Original Manuscript ID: wes-2025-1

Original Article Title: “Wind Turbine Gearbox Operation Monitoring Using High-Resolution Distributed Fiber Optic Sensing”

To: Wind Energy Science

Re: Response to reviewers

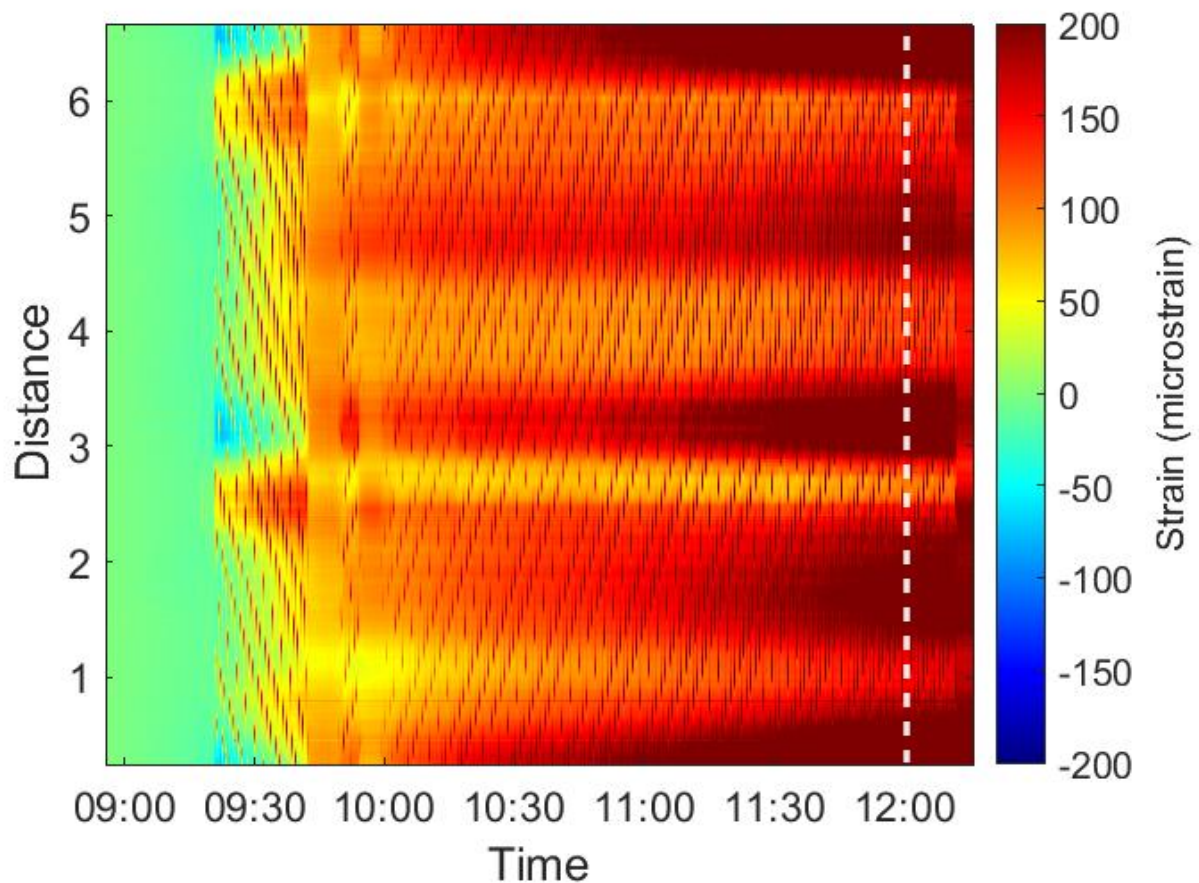
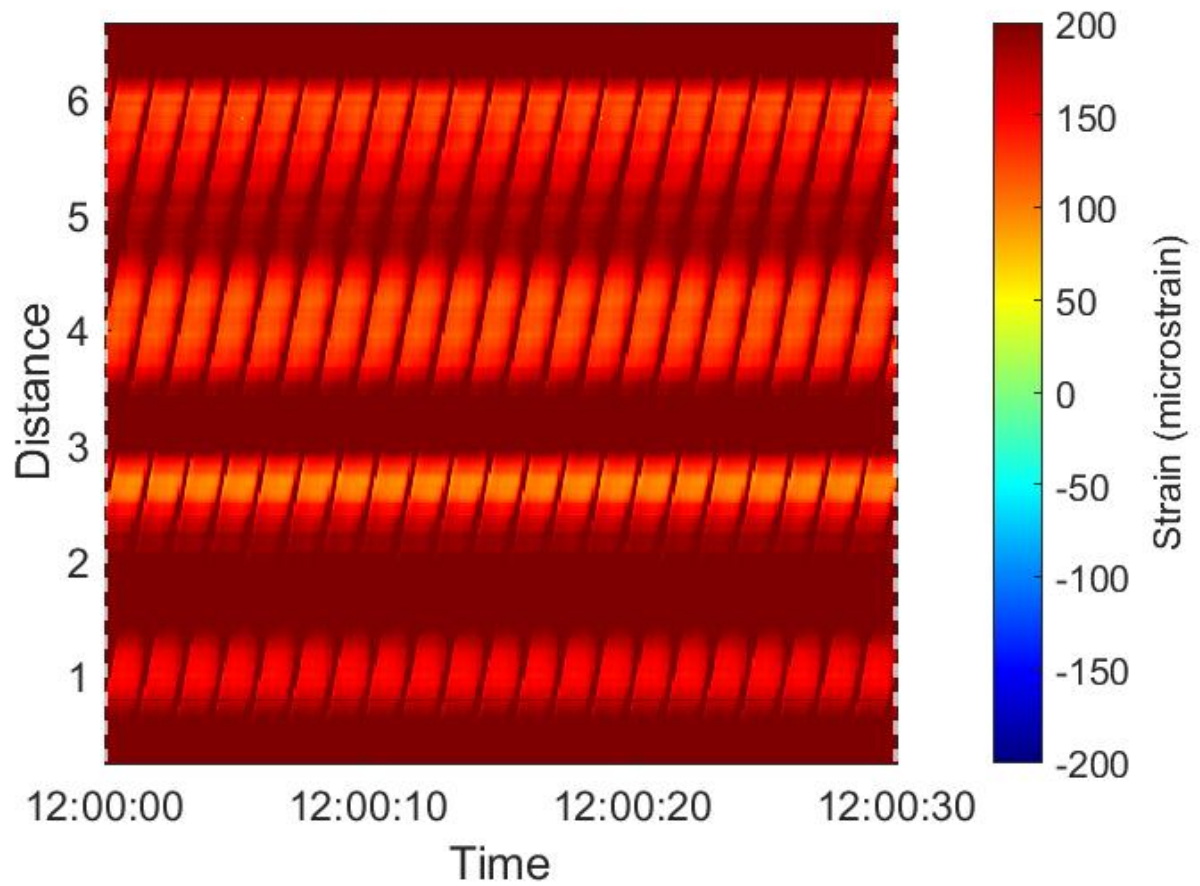
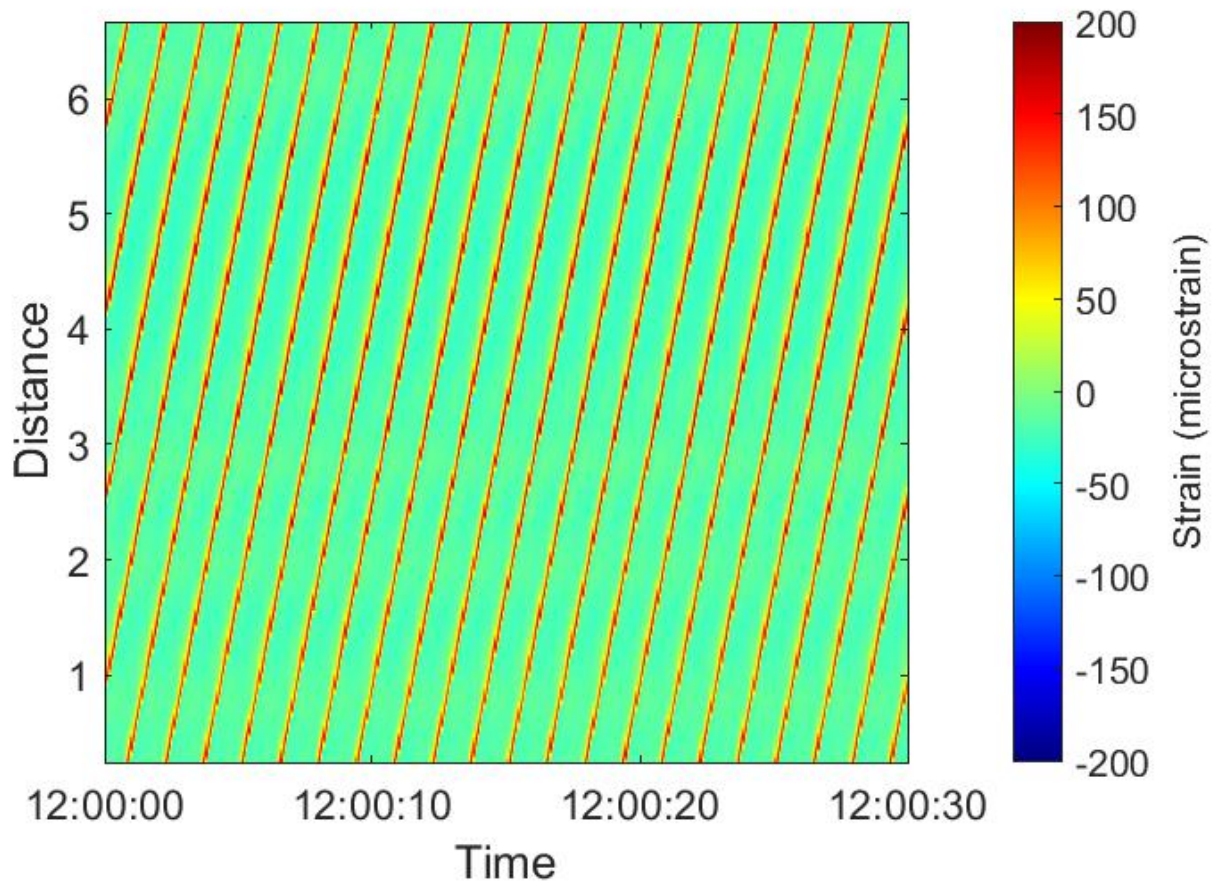
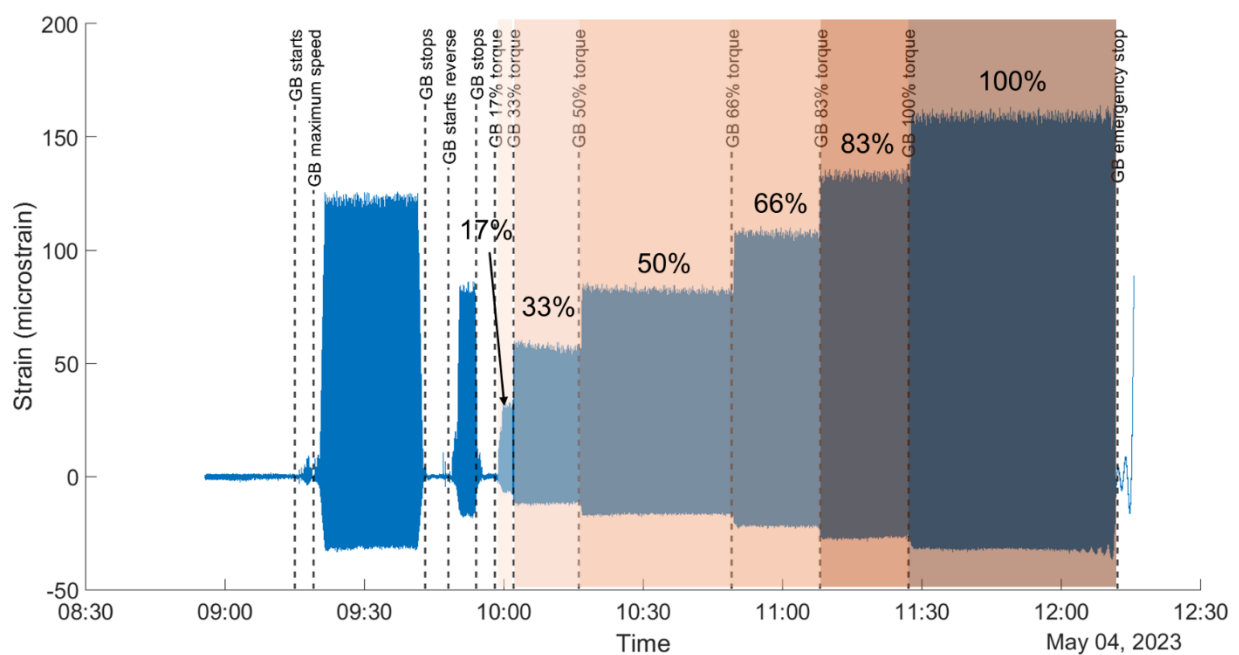
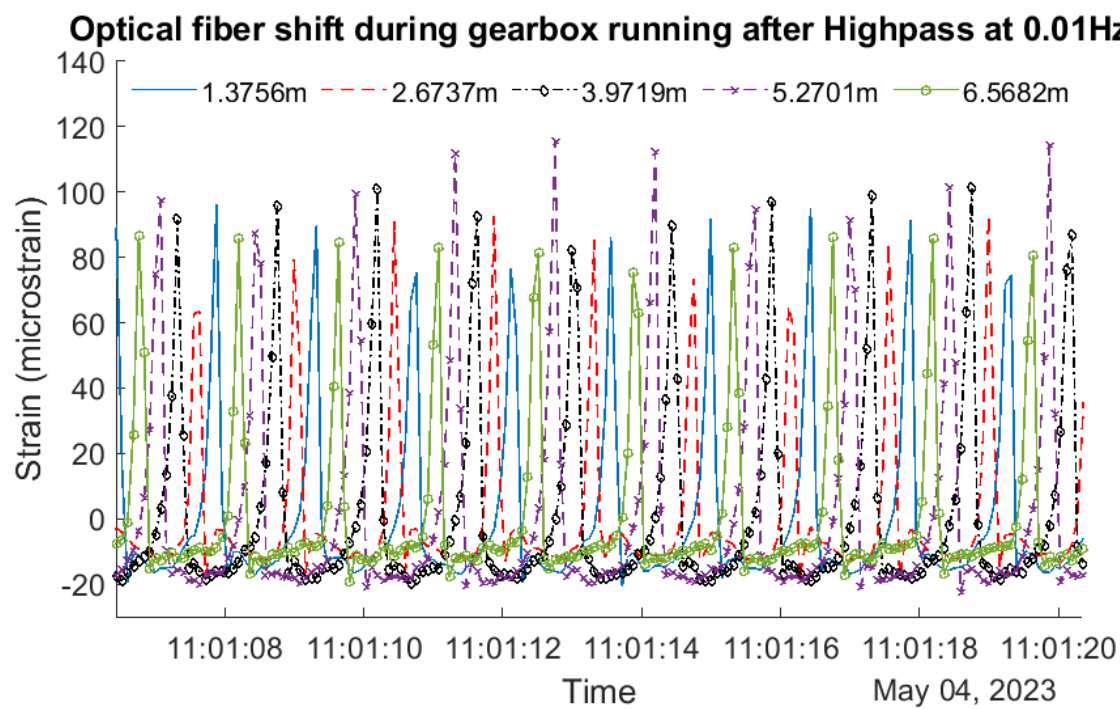
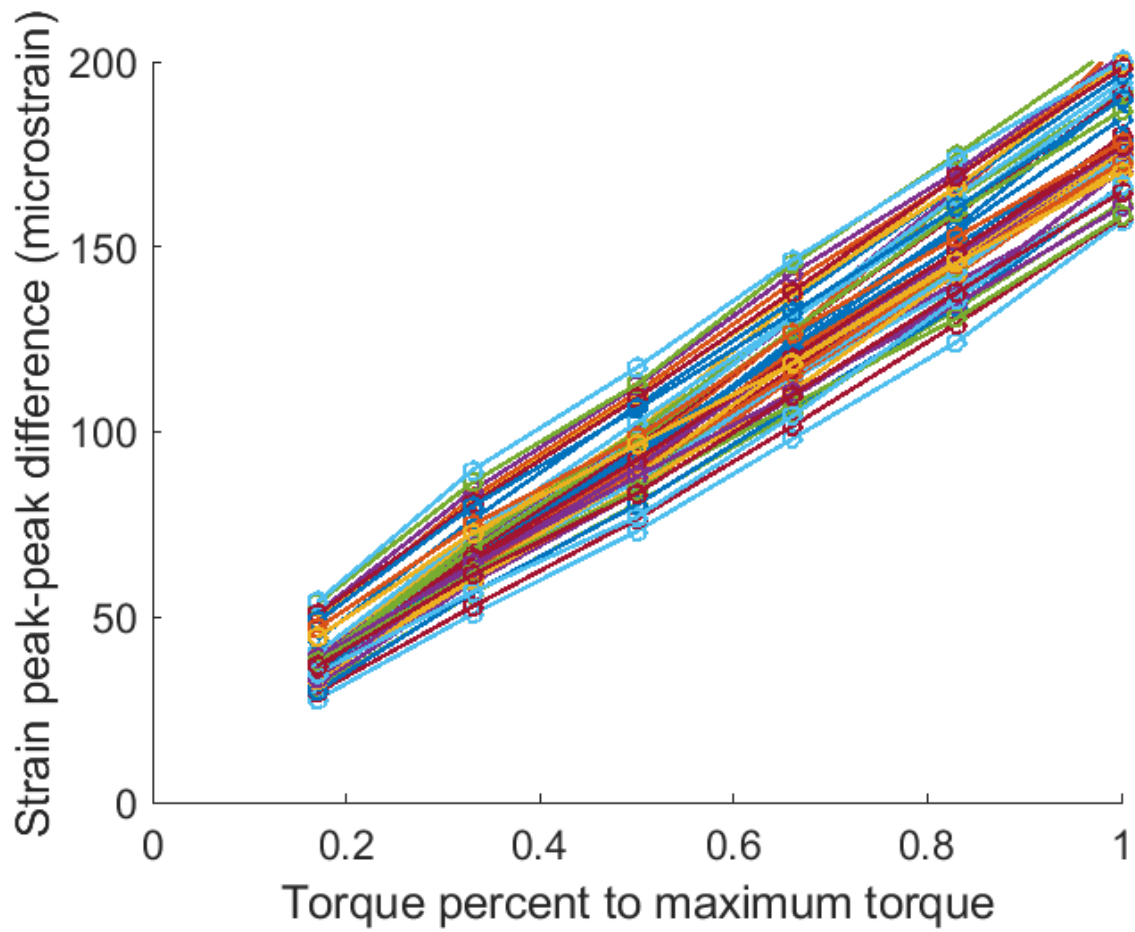
Overall the paper is well written, structured and presented. I suggest revising figures

Figures 3, 5, 6, 8 and check legends and units, font size and printing quality.

We appreciate this comment from the reviewer. We modified the mentioned figures, and they can be seen in the supplement document below:
